Site Specific Management Plan 007 - Waikanae River
MacKays to Peka Peka Expressway
M2PP-121-D-MPL-0007

SITE SPECIFIC MANAGEMENT PLAN - WAIKANAE RIVER AREA [SSMP 7 - SECTOR 470]

Appendix 2: CONSULTATION, FEEDBACK AND RESPONSES
Site Specific Management Plan 007 - Waikanae River
MacKays to Peka Peka Expressway
M2PP-121-D-MPL-0007

KCDC REVIEWERS COMMENTS: JW=Julia Williams- Landscape Architect; DP = Deyana Popova-Urban Designer; SK=Stu Kilmister-CWB Planner; SM= Shona Myers-ecologist – documented and meeting notes responses

Title: SSMP 7 - SHEET 7 CROSS SECTIONS

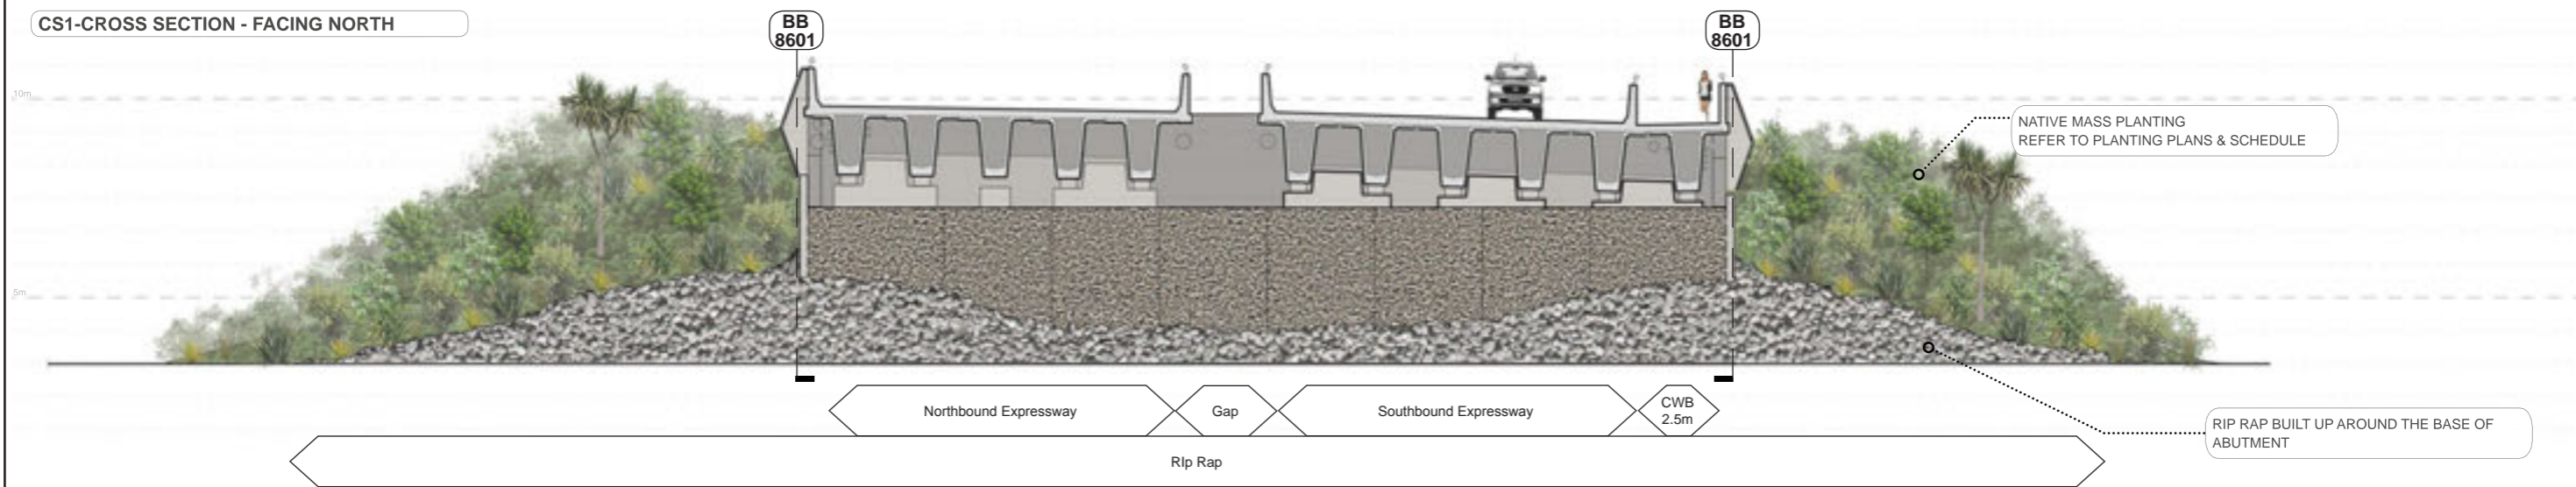
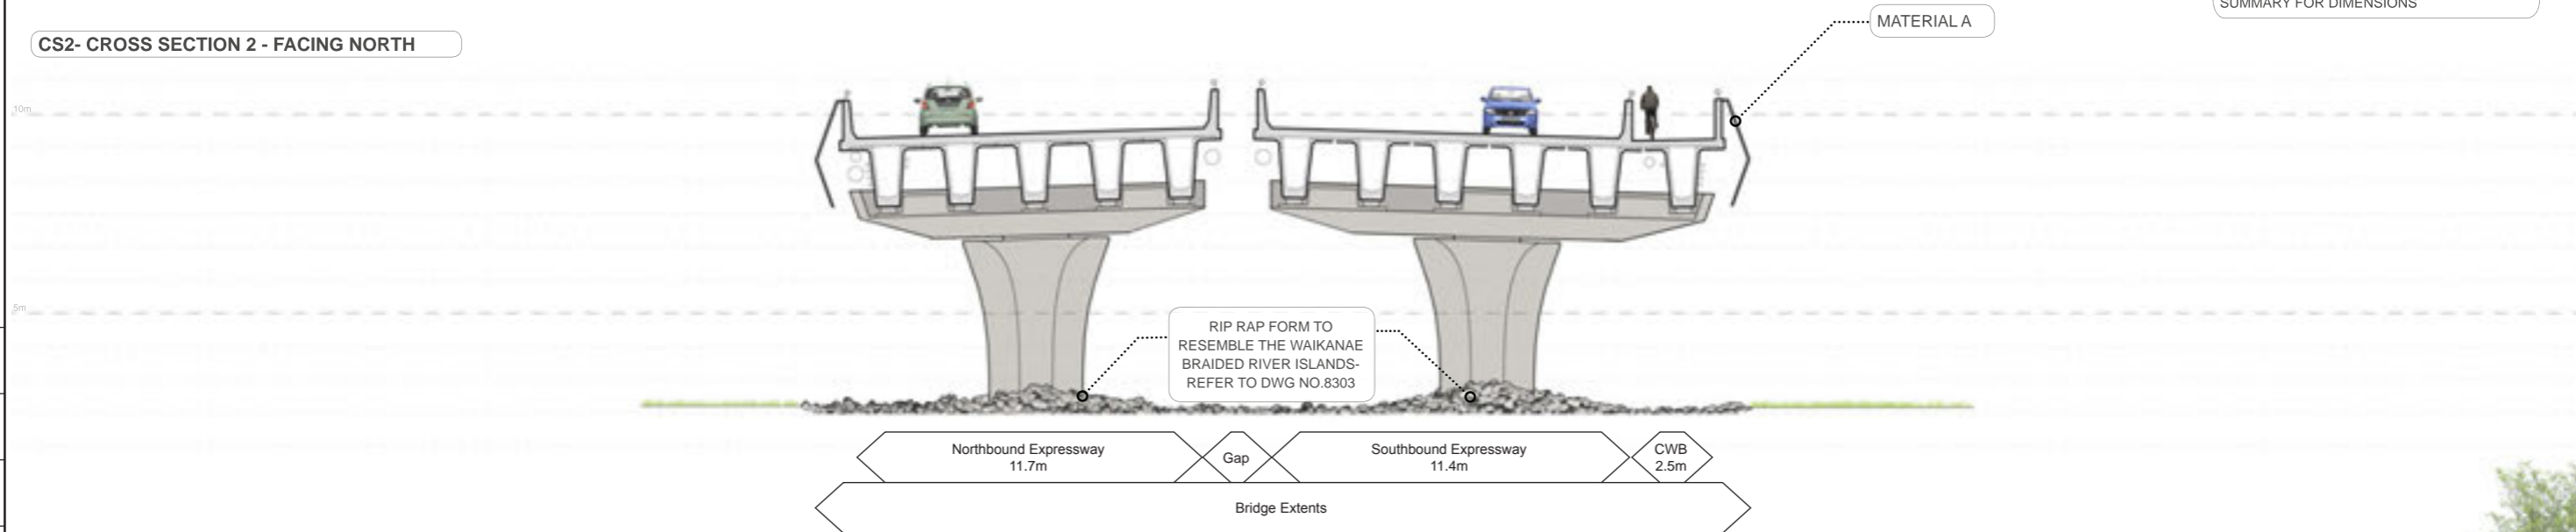
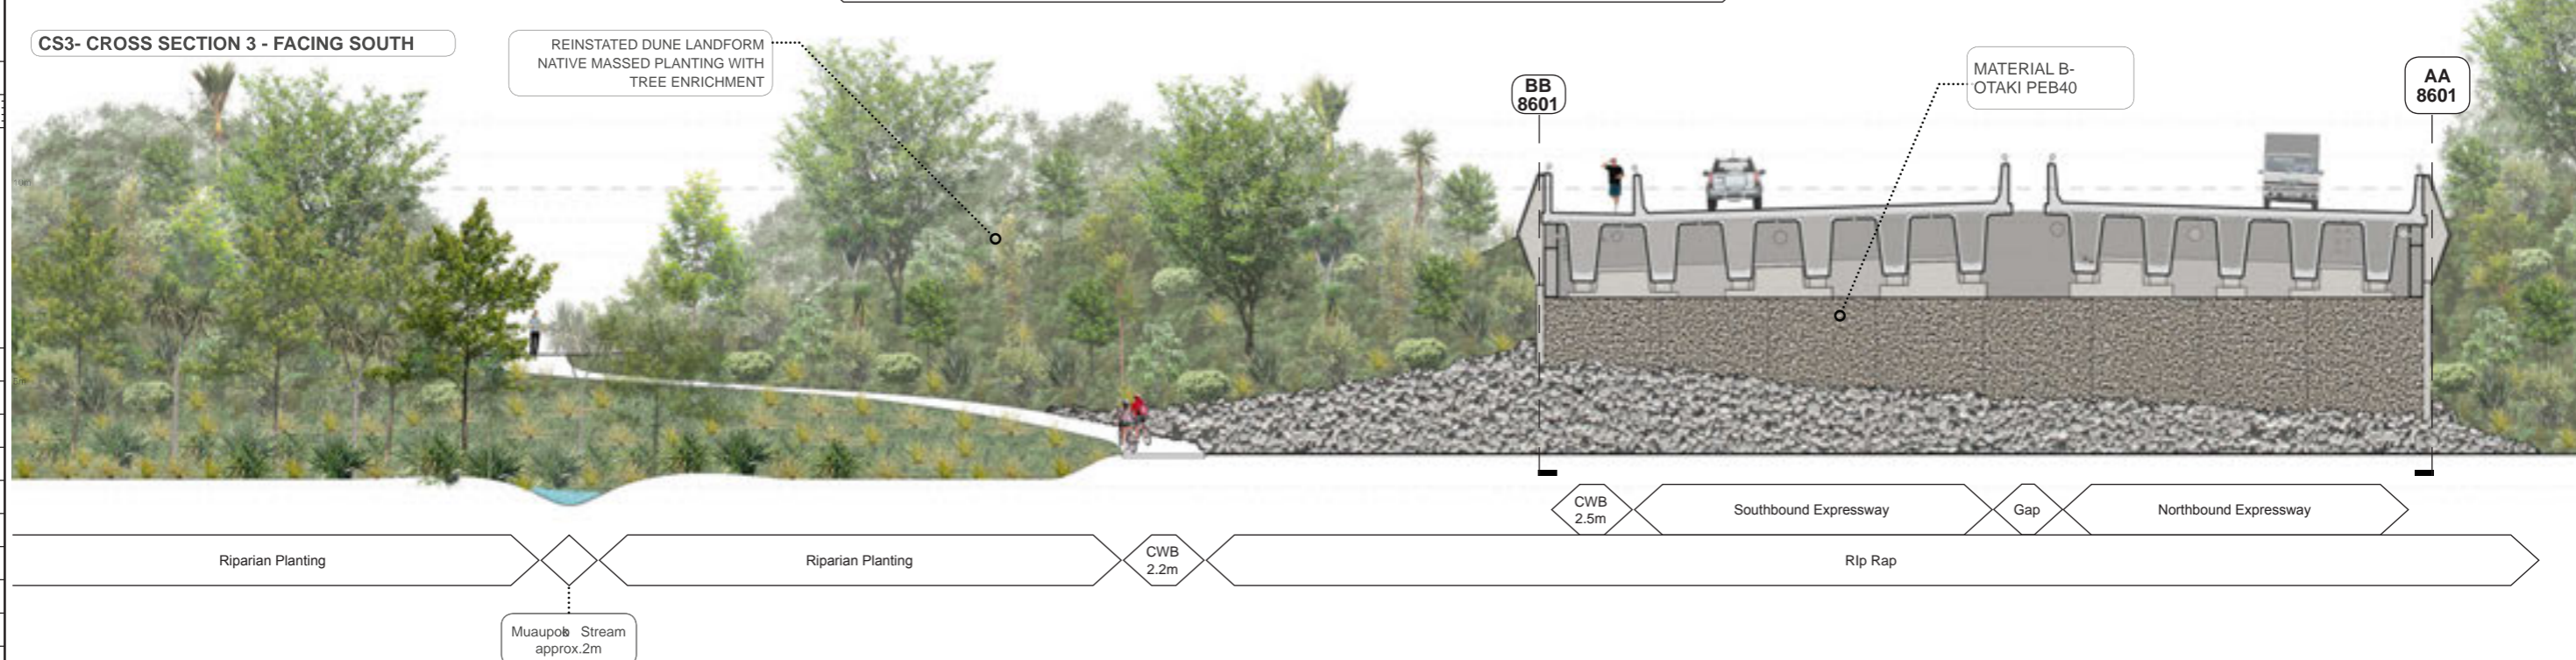
Informal notes:	JW	Sheet 6 Long Section - Notate 2.2m CWB on El Rancho Road cross section		Has been amended.
	Informal notes:	JW	<ul style="list-style-type: none"> • Sheet 7 • top left corner on Cross section 1 – layers are been mixed and plan has whited out area over it 		Printing error has been corrected.
	Informal notes:	JW	Sheet 19 Planting sections and details introduces ribbonwood and cabbage trees to riparian planting but they have not been transferred to Sheet 20 Planting Schedule		Plant schedule has been amended accordingly.

PROPOSED PLAN- WAIKANAE RIVER BRIDGE - 1:500@A3

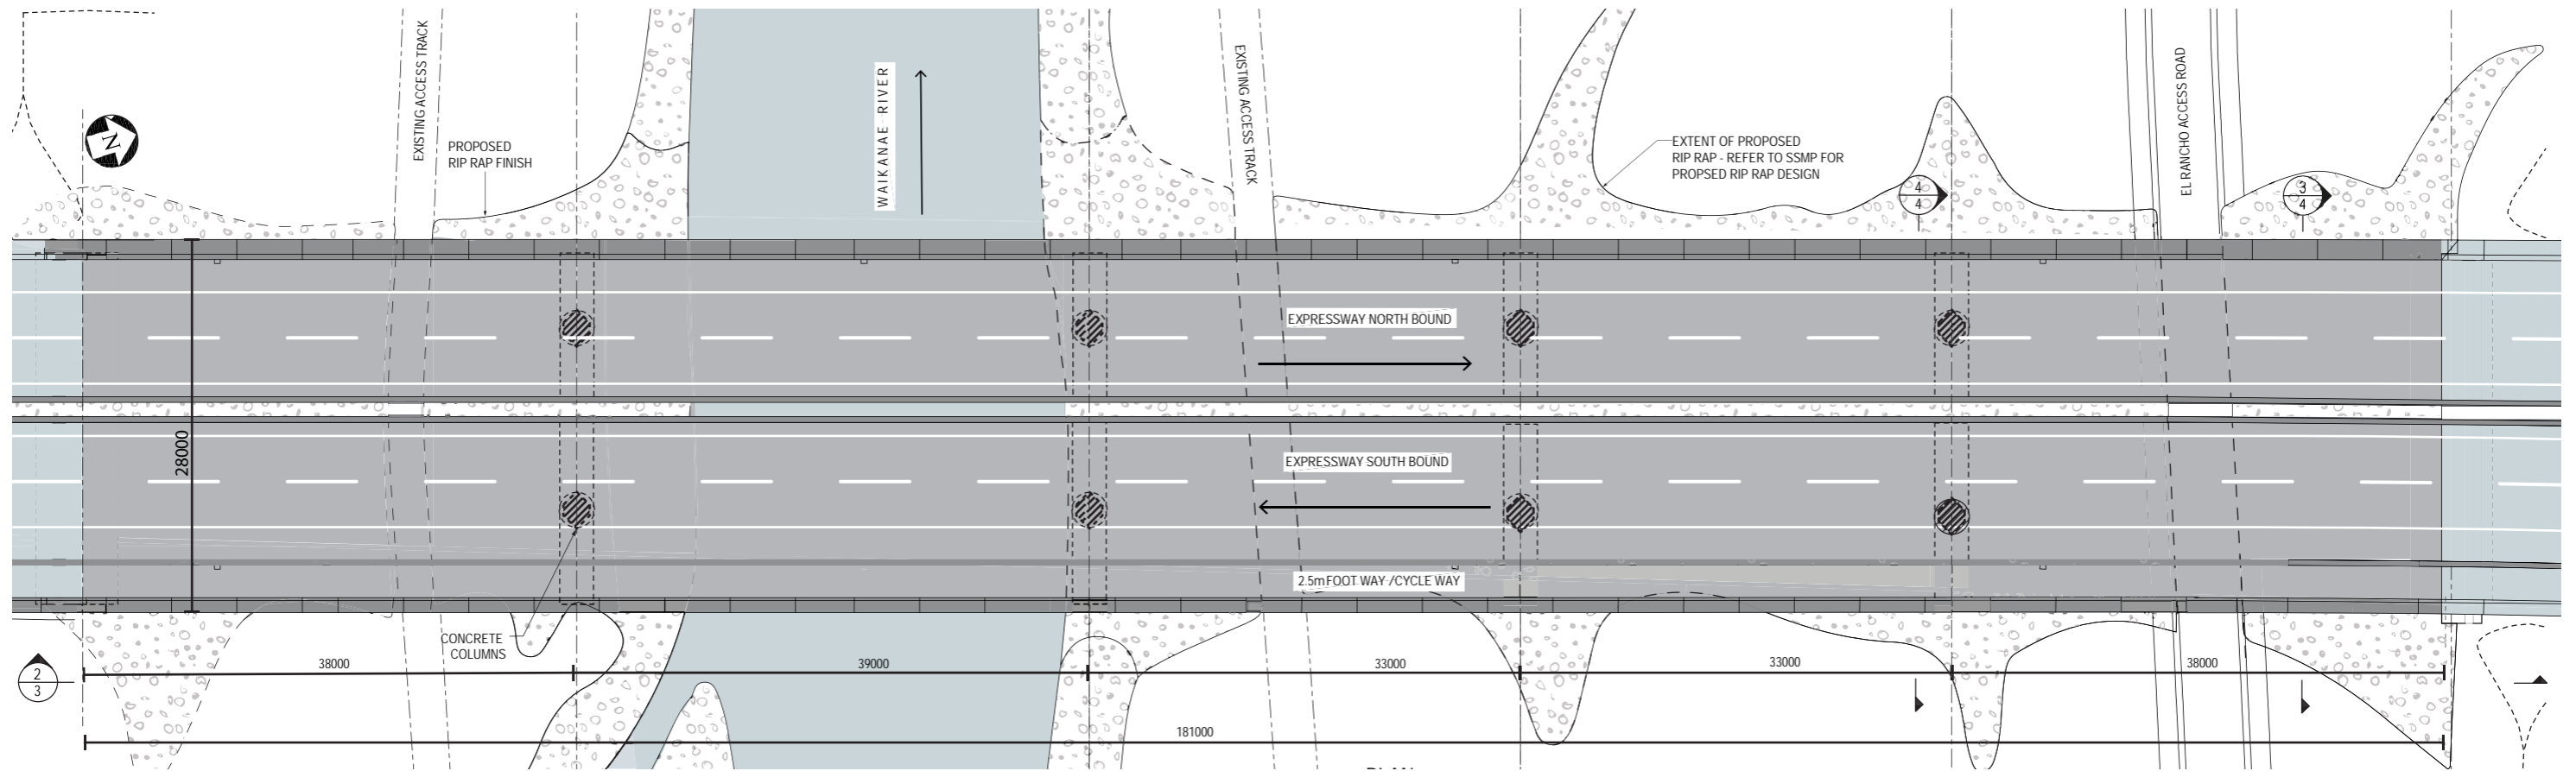
1. Split bridge (1m gap)
2. No exposed pile caps
3. Narrowed cycleway (3m to 2.5m)
4. Column profile developed

1. Breaks up overhead structure, reduced beam numbers
2. No pile caps required (two piles/col, now 1 pile/col) improves columns interface with the ground plain.
3. Reduced beam numbers and deck area

3. ELEVATION COMPARISON WAIKANAE EAST ELEVATION - 1:500@A3

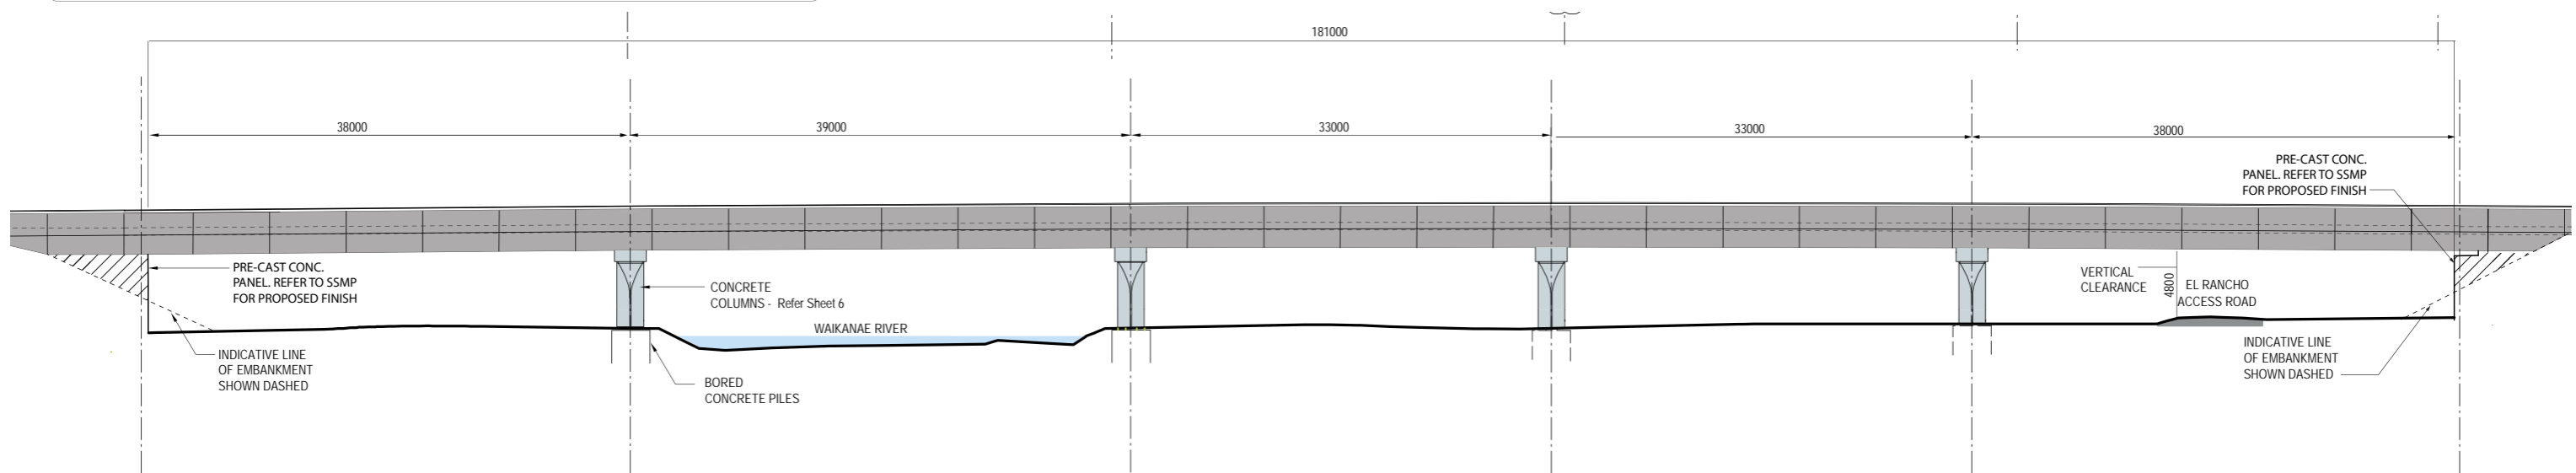
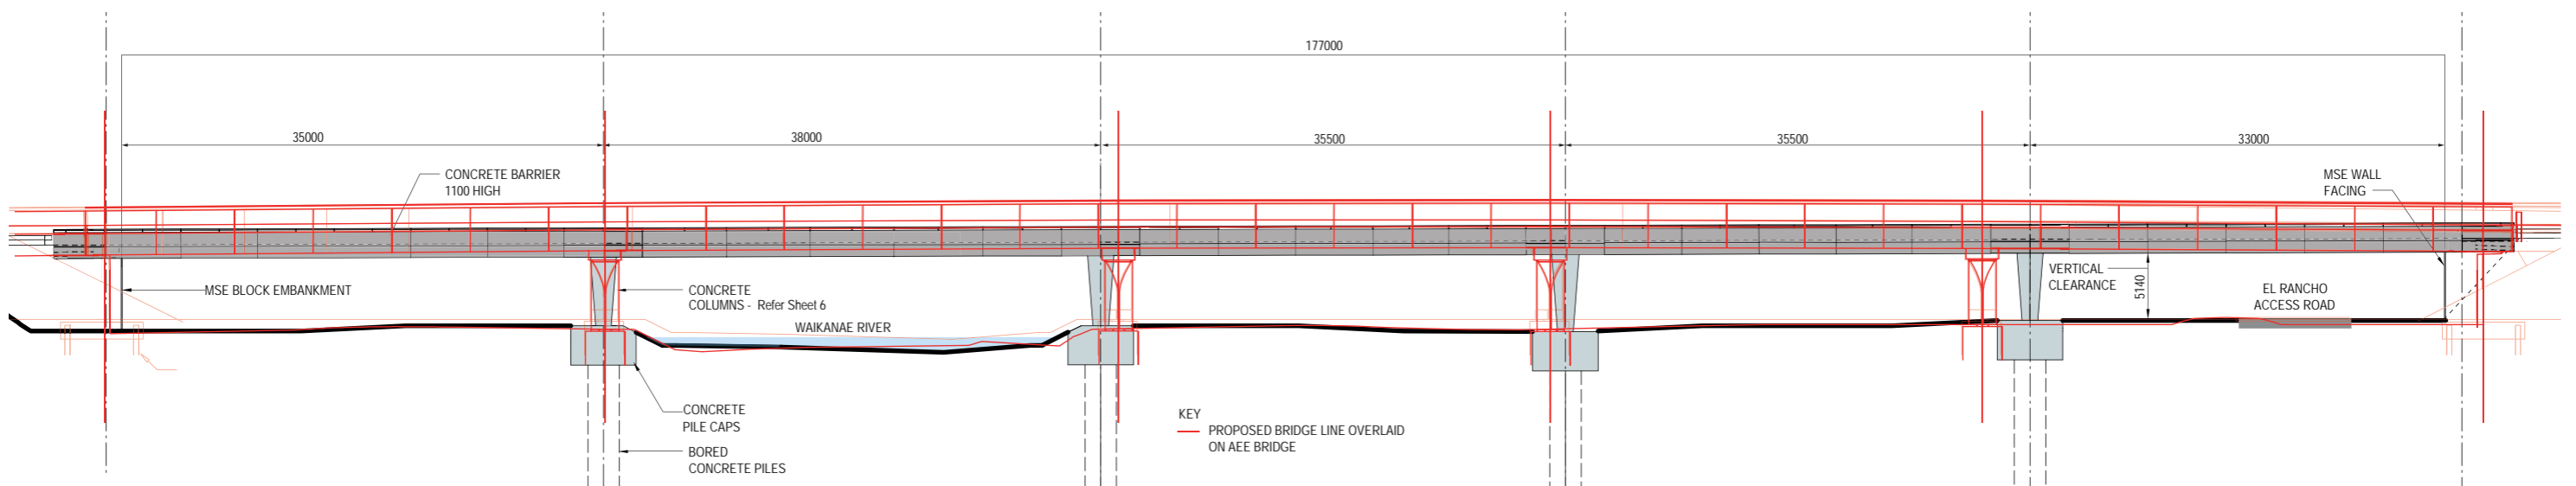
- 1. Pier locations adjusted
- 2. Bridge Barrier drawn larger
- 3. Bridge design changed from integral (Super structure connected to columns) to simply supported.
- 4. Column profile developed

- 1. To tie in with revised beam design and span
- 2. Barrier drawn incorrectly in AEE elevation, (Actual barrier depth unchanged from AEE simulations)
- 3. Constructability issues because of seismic requirements.
- 4. Increased structural core based on geotech investigations carried out post AEE, while still providing the sculptural outer.
- 5. Integral connections difficult to build without increasing structural element sizes further.
